SUNDRY NOTICES AND REPORTS ON WELLS
Do not use this form for proposals to drill or to re-enter an abandoned well. Use Form 3160-3 (APD) for such proposals.

8. Well Name and No.
ALLIED 7 FEDERAL 4

9. API Well No.
30-015-25973

**Permanent Abandonment of Federal Wells
Conditions of Approval (LPC Habitat)**

CURRENT WELLBORE

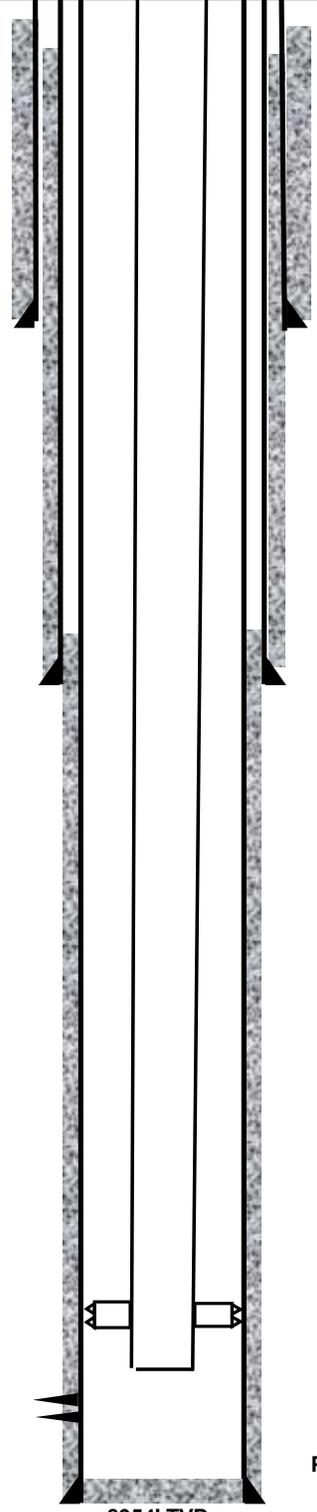
Integrate the following into above plan:

- Yates@2089:25sx from 2139' to 2018'
- Ensure cement to surface inside 5.5" casing and 5.5"-8.625" annulus with perf and squeeze for 375sx plug. T.Salt plug and surface plug from 100' should be perf and squeezed if 375sx plug cannot be circulated to surface in the 5.5"-8.625" annulus
- Tag and verify depth of all plugs

Sundry ID		2668715					
Plug Type	Top	Bottom	Length	Tag	Sacks	Notes	
Surface Plug	0.00	100.00	100.00	Tag/Verify	375.00	Same as BOS plug	
Shoe Plug	414.31	519.00	104.69	Tag/Verify	375.00	Same as BOS plug	
Top of Salt @ 673	616.27	723.00	106.73	Tag/Verify	375.00	Same as BOS plug	
Base of Salt @ 1507	1441.93	1557.00	115.07	Tag/Verify	375.00		
				If solid base no need to Tag (CIBP present and/or Mechanical Integrity Test), If Perf & Sqz then Tag, Leak Test all CIBP if no Open Perforations			
Yates @ 2089	2018.11	2139.00	120.89		25.00		
Shoe Plug	2426.98	2552.00	125.02	Tag/Verify	85.00	Same as delaware plug	
				If solid base no need to Tag (CIBP present and/or Mechanical Integrity Test), If Perf & Sqz then Tag, Leak Test all CIBP if no Open Perforations			
Delaware @ 2972	2892.28	3022.00	129.72		85.00
